4TH & COLUMBIA

DOWNTOWN DESIGN REVIEW BOARD

EARLY DESIGN GUIDANCE 2 - 03.01.16

PROJECT NO. 3020955

A Podium Circulation & Amenity East/West Section

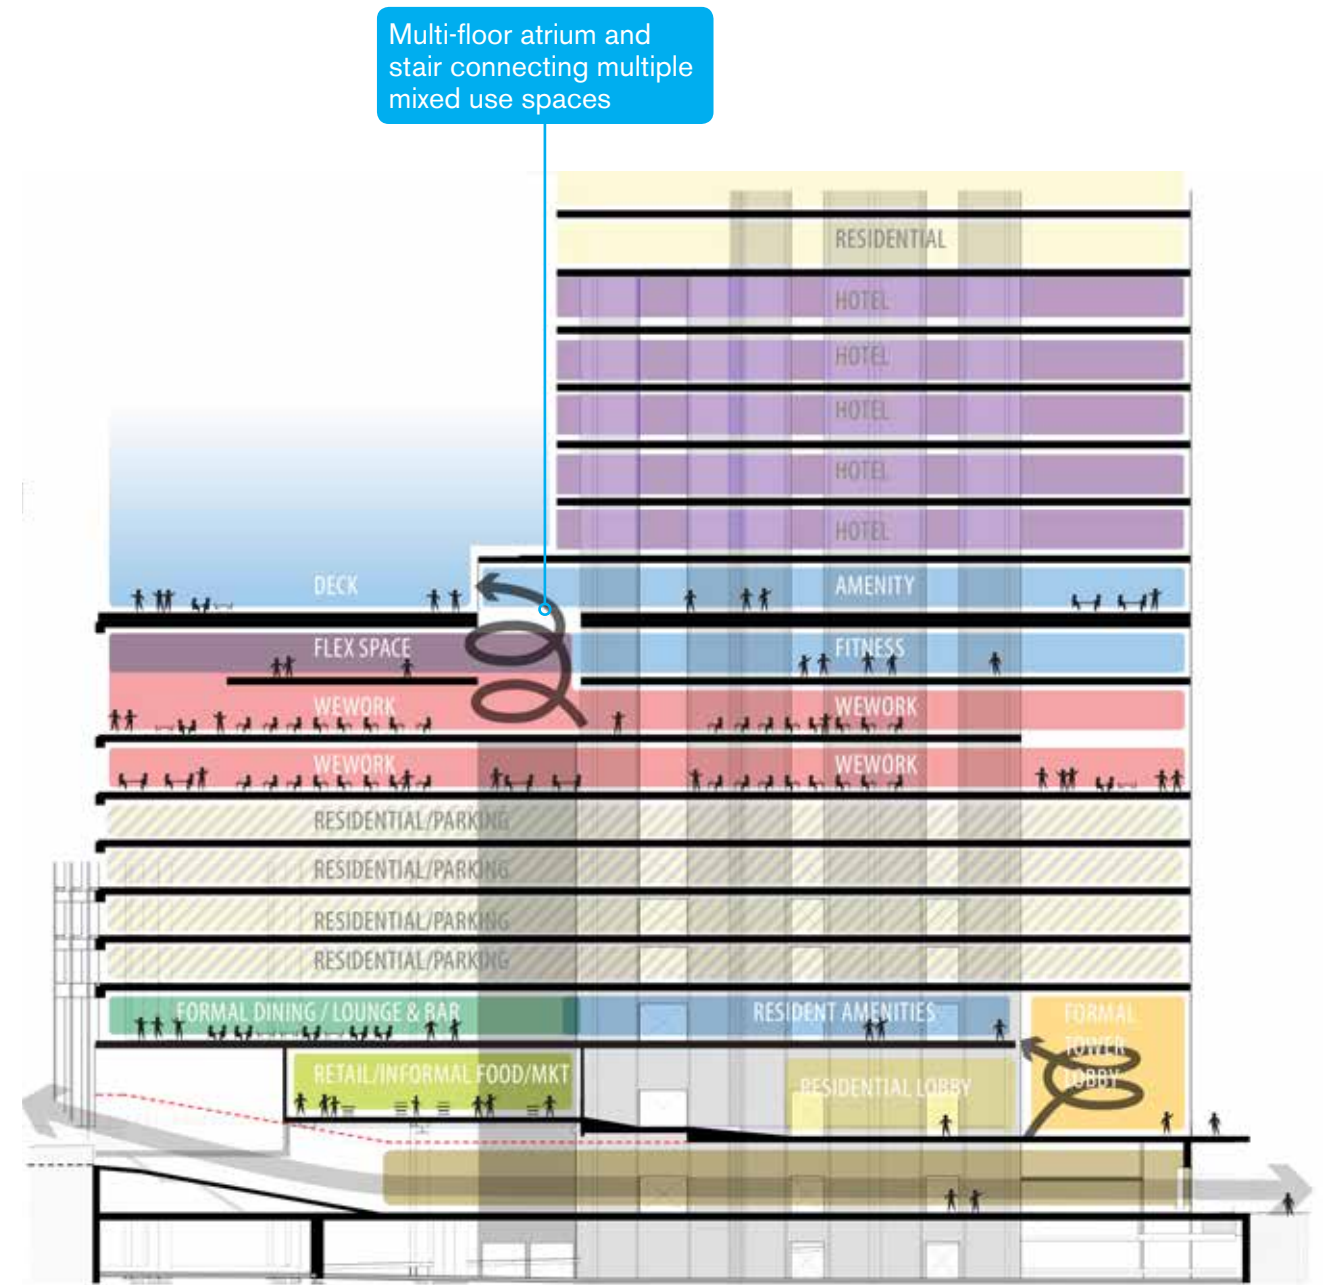
COMMENT 1B Public Access and Sectional Interest

RESPONSE – The concept of enhanced connectivity and user interaction through the mixing zone is augmented by several strategies, including a variety of circulation options for entry, exiting, and moving between floors, uninterrupted visual connections at strategic locations, and symbiotic program relationships.

Double-height spaces with highly visible feature stairs have also been added to the retail and residential lobby zones. Likewise, the strategic placement of the main amenity floor and its roof deck in-between the hotel program above and the office below, with a connecting stair in the multi-level open space, creates a shareable amenity core accessible to all residents and their guests, and where a majority of building users can cross paths daily.

A View from Jose P Rizal Park

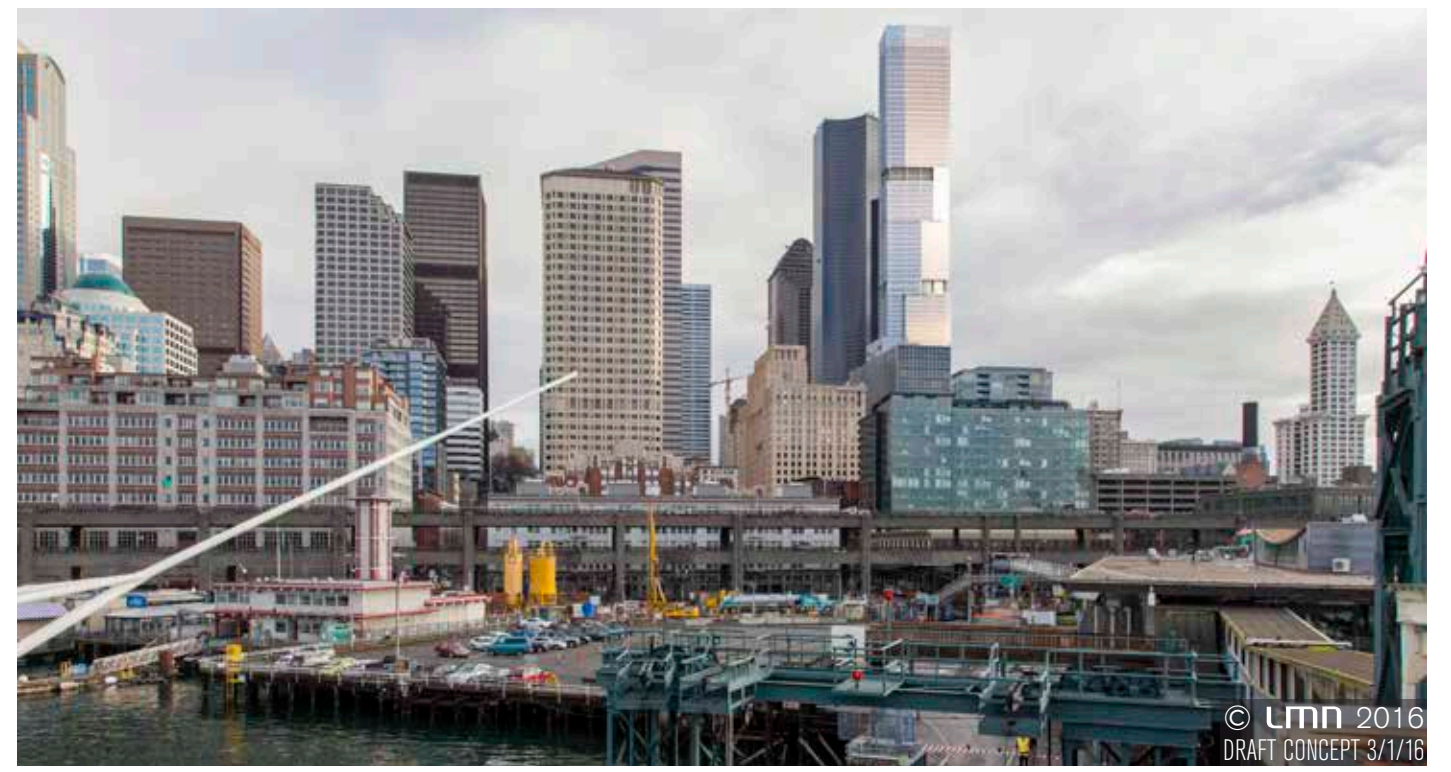
COMMENT 1C Tower Placement

RESPONSE – Additional viewpoints have been added to further illustrate the skyline composition. The study validates the current tower placement which provides ample space between neighboring towers and offers a less “bunched” downtown skyline, consistent with previous viewpoints.

A Mid-block Pass Through and Drop-off

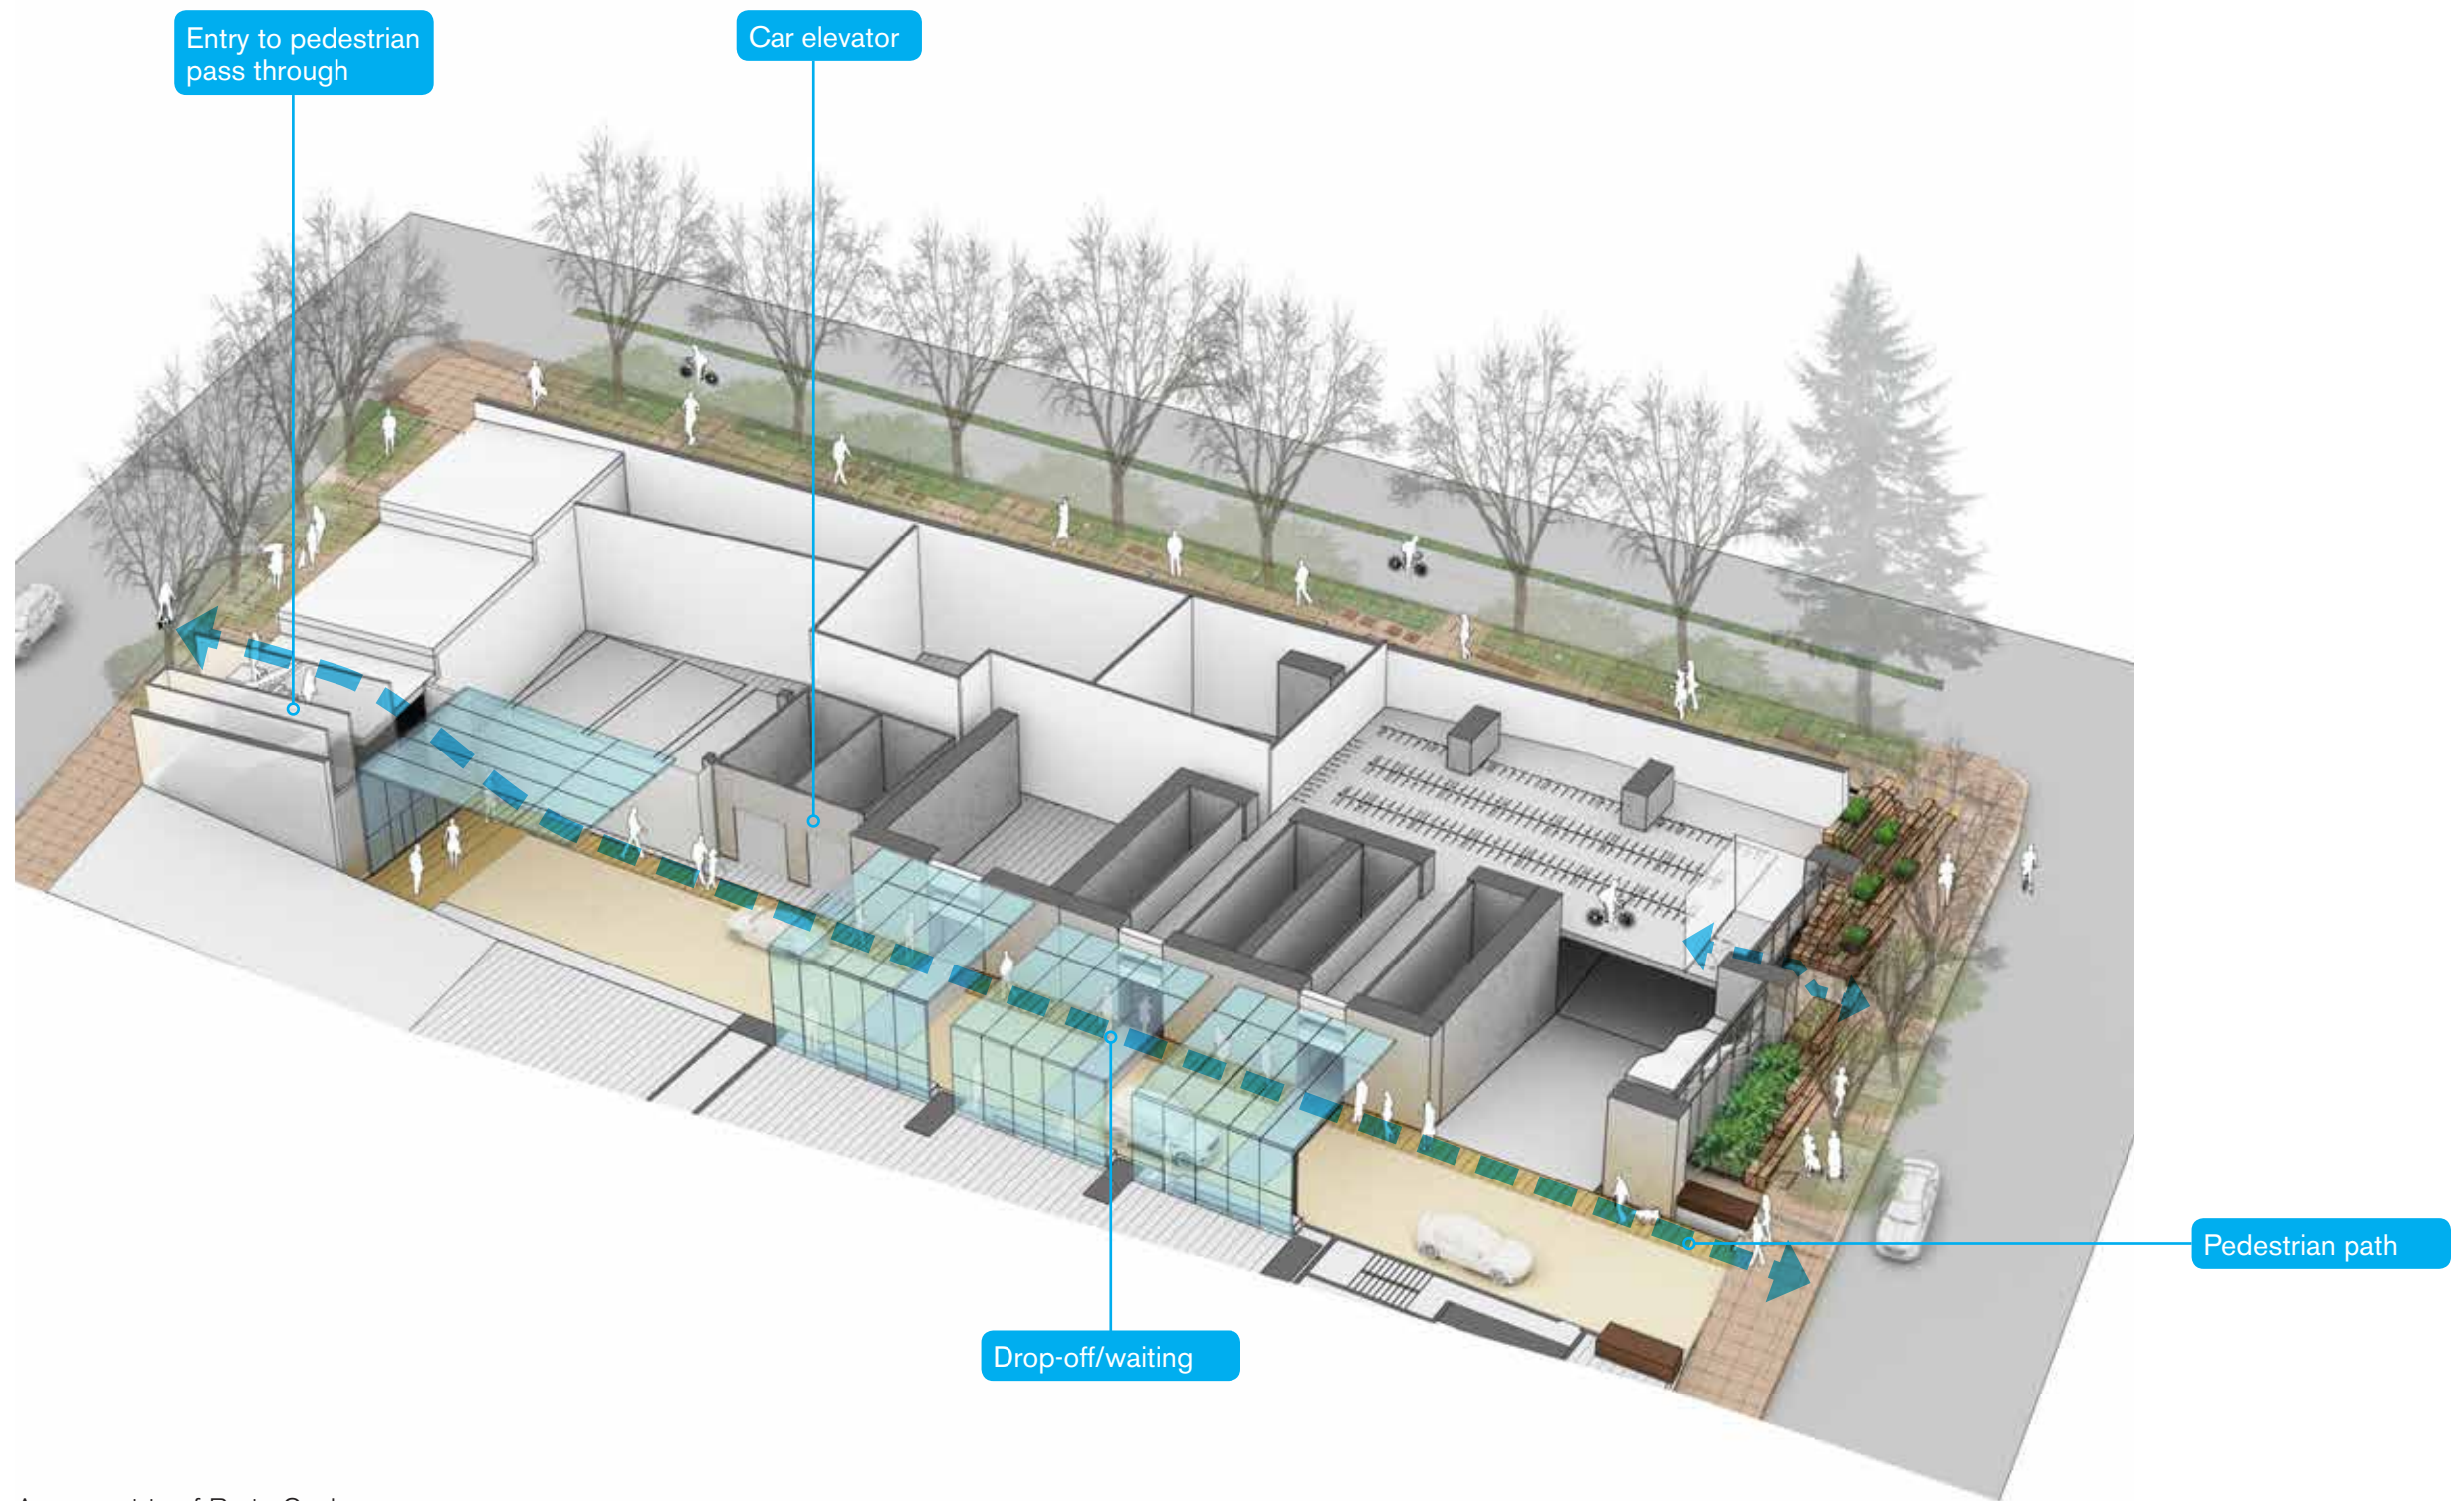
COMMENT 2A Mid-Block Drive/Walk Pass-Through

The Board characterized this as a “new model” of how to better design these zones which are usually relegated to unpainted, below grade garages (the below-grade parking drop-off and pedestrian access off 6th at Pacific Place was later mentioned as a more positive precedent). The exterior portals of this pass-through should be appropriately designed and welcoming to pedestrians. Detailed plans, elevations and full material specifications should be provided at subsequent meetings. [C1; C4; E1.1.a; E2.2; D6]

RESPONSE – The design of this mid-block drive/walk pass-through has been developed further, anchoring the tower firmly into the city fabric. The updated proposal notably eliminates the second curb cut previously proposed on Columbia St and in turn, emphasis has been put onto enhancing the vehicle/pedestrian drop-off zone “street level experience” with high quality finishes and attractive lighting to create a welcoming space for pedestrians. Pedestrians have the option of accessing the elevator bank for connections to retail and lobbies, or passing through the full half-block with a transparent, highly visible stairwell connecting to grade at Columbia St. The exterior portal on Cherry St has been revised to set back from the property line to match the tower massing and rotation, so it can be better recognized as a proper entry for pedestrians rather than a portal for vehicle entry as shown in the previous scheme. Overhead weather protection, integrated wayfinding markers, and hardscape paving patterns at the entries further denote the pedestrian route.

Corner of Cherry St and 4th Ave

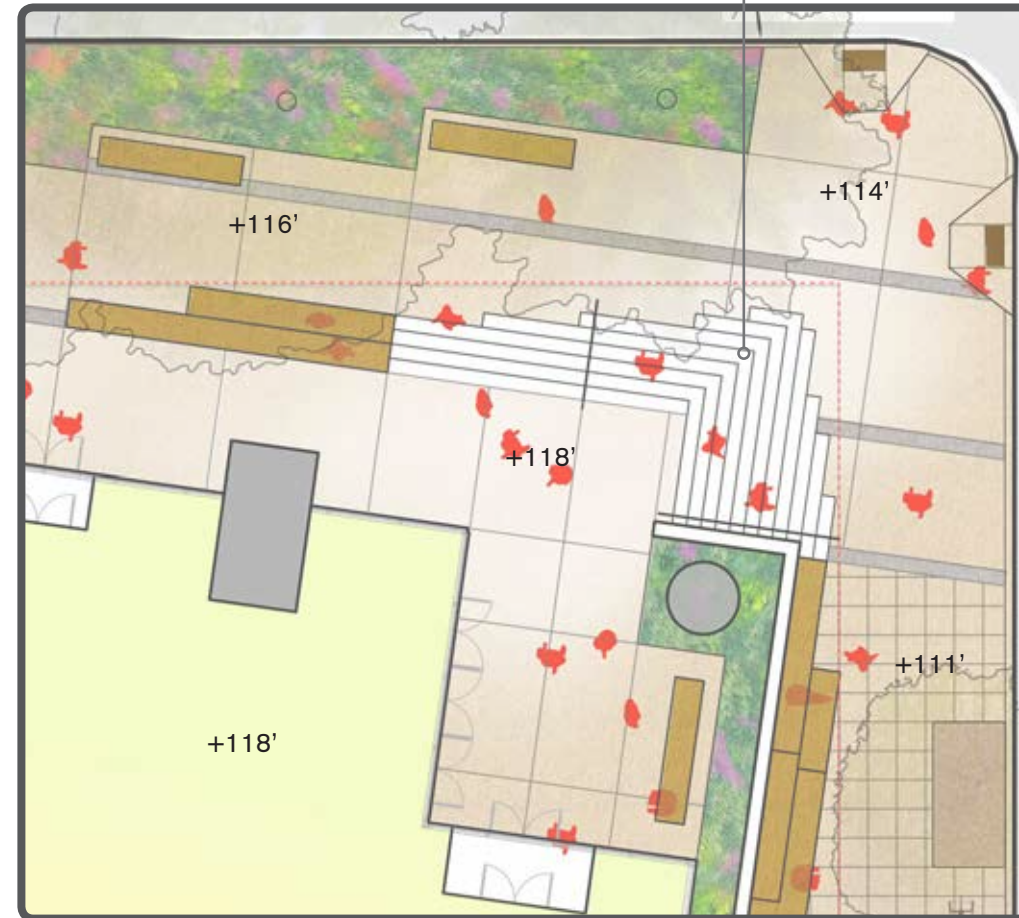
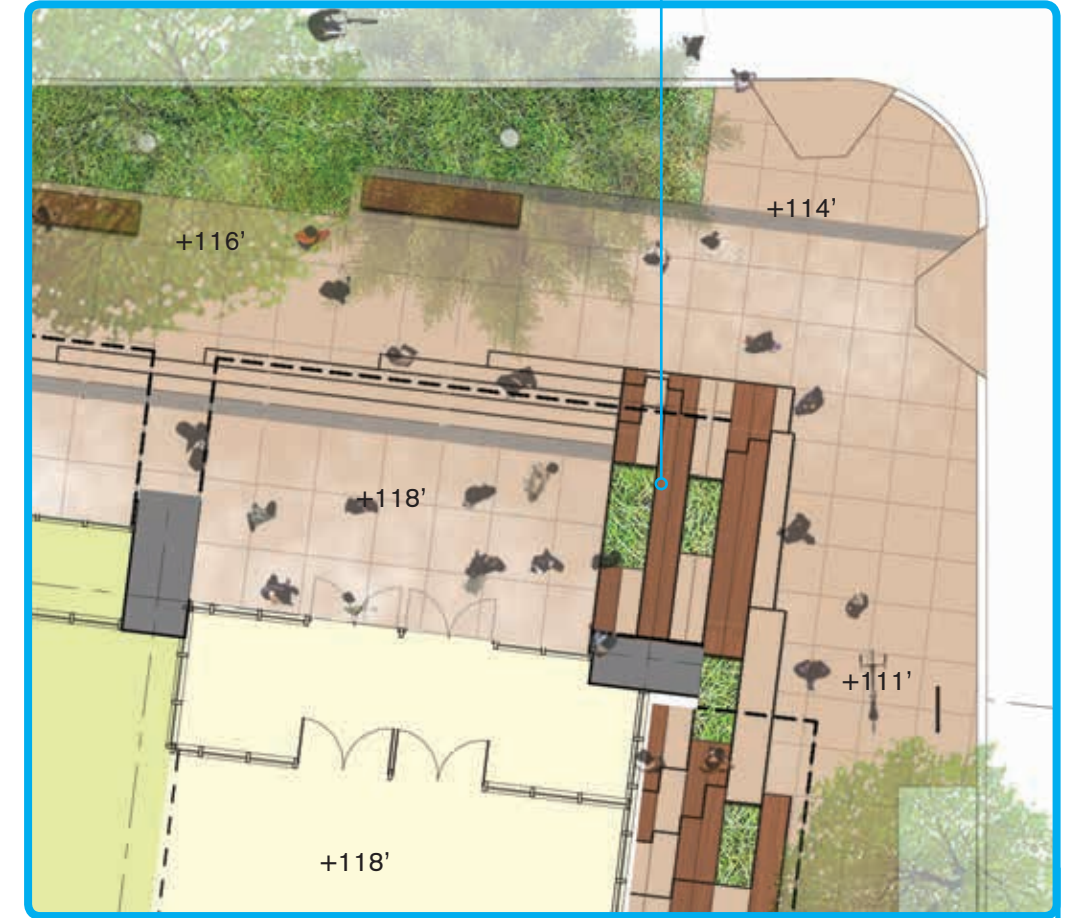
COMMENT 2B Sidewalk to Building

Stair perceived as tall and intimidating

RESPONSE – The floor level of the southeast corner at its current height enables a small Cherry St retail space and resident entry below, while allowing a contiguous resident lobby above. In order to achieve a more refined and less intimidating edge, wide wood platforms, seating and planters have been introduced on the south side of this corner which helps break down the scale and rise of the stair. This layout not only creates a visually compelling architectural feature from the sidewalk perspective, but it also activates a greater portion of the site edge with a public amenity and softens the sharp corner presented in the previous scheme.

Scale of the stair is broken down to make it more inviting

Columbia St Model Elevation

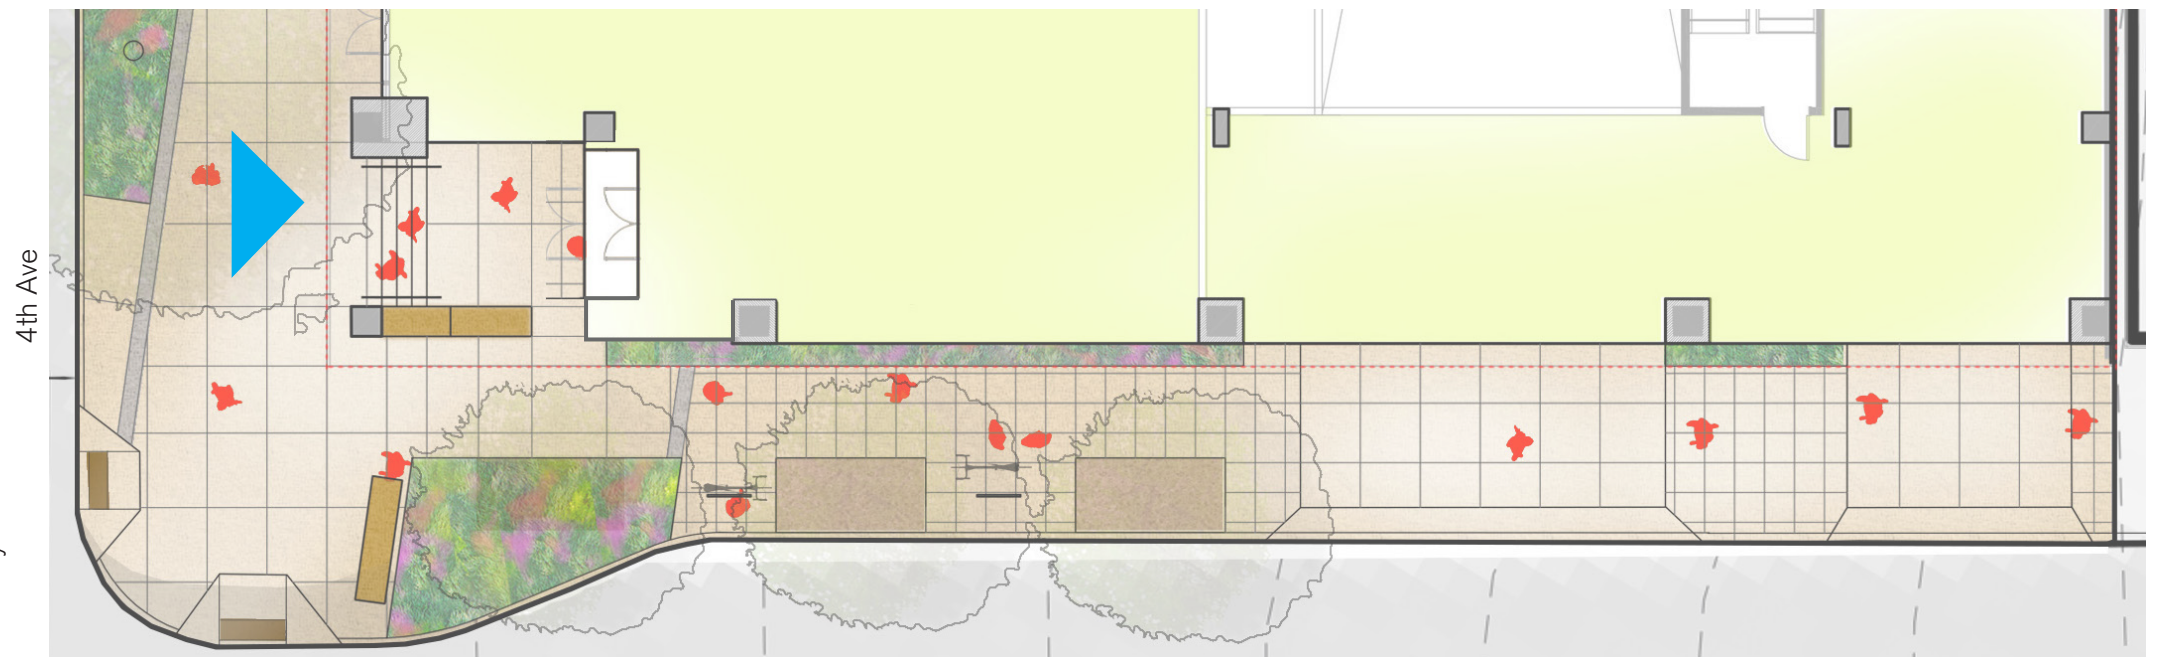
COMMENT 2C Lower Elevations on Sloping Side Streets

The Board strongly supported the seating blocks and exterior stair on Cherry St (pg 79) which helps animate that street-level facade. The Board agreed the rest of that 'plinth' and the wall on Columbia should first be activated with small commercial uses, articulated materials and seating, with only small portions of green wall to assist with necessary transitions. The Board did not accept the tall, half-block, inactive green walls of other nearby projects offered as positive precedents. [C1; C3; D3]

RESPONSE – The redesign of the mid-block drive was the catalyst to improving the facade facing Cherry St. The ‘plinth’ was altogether eliminated when its massing was set back to match the rest of the tower, anchoring the rotated tower massing directly to street level. Likewise, the retail space and bicycle parking access on Cherry St will add active uses that mix residents and passersby, and wraps the transparency of the 4th Ave facades around the corner. The added visual access to the tower, expanded landscape features and interest brought by the active mid-block pass-through and drop-off zone will provide greater visual attraction and activity along Cherry St.
